Appl. No. 10/625,102
Amdt. dated Oct. __, 2005
Reply to Office Action of July 22, 2005

Amendments to the Drawings:

REMARKS/ARGUMENTS

Fig. 3A

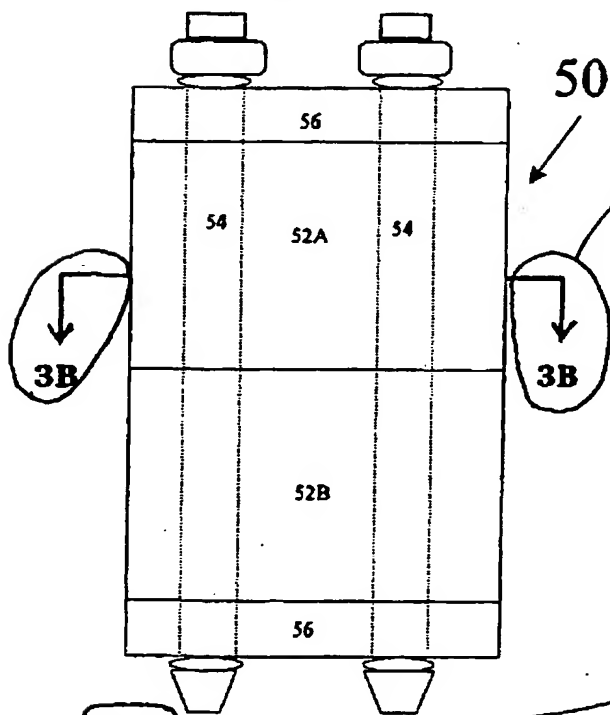
In amended FIG. 3A, the number "244103.T" at the bottom of the figure has been deleted, and appropriate labels and arrows for cross-sectioning line 3B-3B have been added.

In the July 22, 2005 Office Action, the Examiner requires that the number "244103.1" at the bottom of FIG. 3A and FIG. 5A be deleted. In response, Applicant respectfully submits replacement sheets, as well as an annotated marked-up copy showing change, for revised FIGS. 3A and 5A, in which the number "244103.1" at the bottom of these figures has been deleted.

The Examiner also requires that line 3B-3B, line 4B-4B and line 5B-5B be shown in FIGS. 3A, 4A and 5A, respectively, to show where the cross-sections for FIGS. 3B, 4B and 5B are coming from. In response, Applicant respectfully submits replacement sheets, as well as annotated marked-up copy showing change, for revised FIGS. 3A, 4A and 5A showing line 3B-3B, line 4B-4B and line 5B-5B, respectively.

Fig. 4A

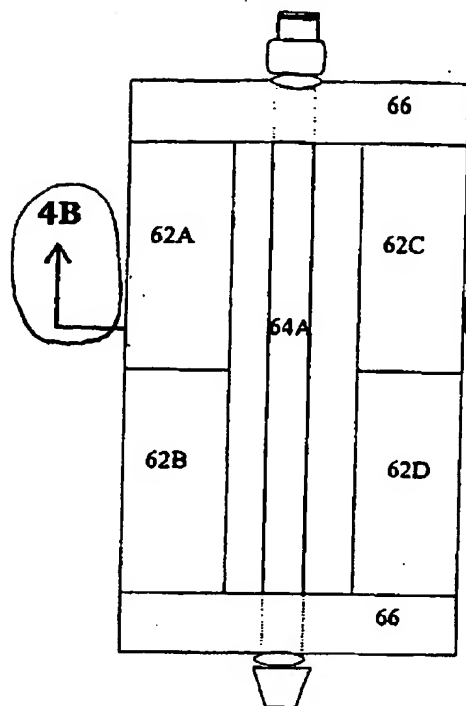
In amended FIG. 4A, appropriate labels and arrows for cross-sectioning line 4B-4B have been added.

*the label and arrows for
 line 4B-4B added*

Fig. 5A

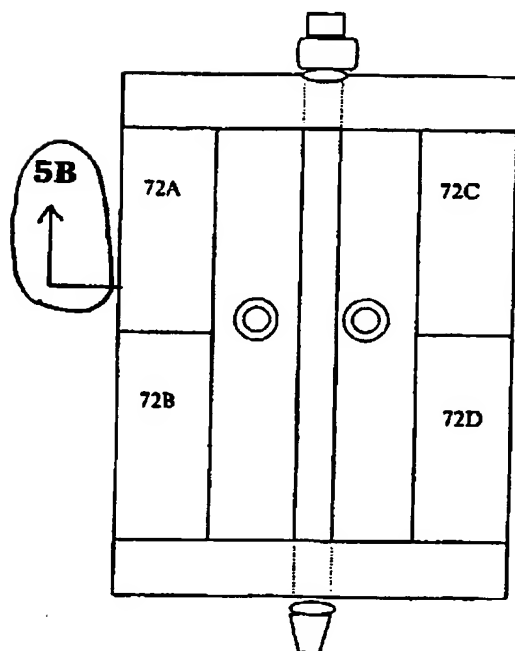
In amended FIG. 5A, the number "244103.T" at the bottom of the figure has been deleted, and appropriate labels and arrows for cross-sectioning line 5B-5B have been added.

*the label and arrows
 for line 5B-5B added*

the number "244103.1" deleted

Fig. 6

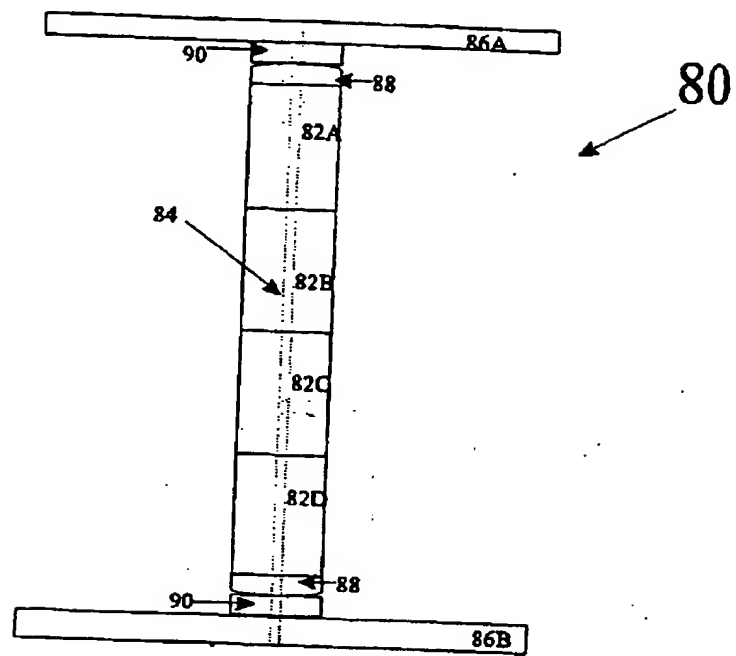
In addition, the Examiner objected to the drawings because reference numeral 88 shown in FIG. 6 does not appear to be described in the specification. In response, the Applicant has amended the paragraph [0057] of the specification to add in the description the reference numeral 88 shown in FIG. 6, which was inadvertently omitted previously. In view of the statement at the end of the paragraph [0057] that "this embodiment can be further modified in accordance with the teachings and principles discussed above with respect to embodiments 10, 10A, 50, 60 and 70," the amendment to this paragraph is supported by element 28 in FIG. 2 and the related text in the paragraph [0047].

The paragraph [0057] of the specification has been amended to include the description of reference numeral 88 shown in FIG. 6, which was inadvertently omitted previously. In view of the statement at the end of this paragraph that "this embodiment can be further modified in accordance with the teachings and principles discussed above with respect to embodiments 10, 10A, 50, 60 and 70," the amendment to this paragraph is supported by element 28 in FIG. 2 and the related text in the paragraph [0047].

Displacement *Q* the unit for displacement, (mm), deleted
 Fig. 7

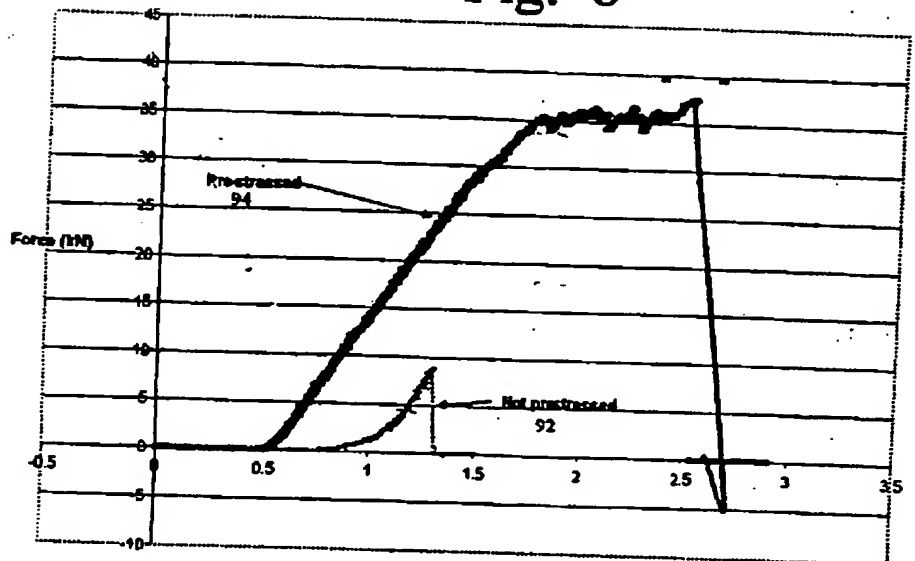
In amended FIG. 7, the unit for displacement in parentheses, (mm), has been deleted. It is respectfully submitted that, while the displacement values in FIG. 7 are indicative of the measure of strain, the numerical values for displacement are provided only for the purpose of comparison between the prestressed and non-prestressed results.
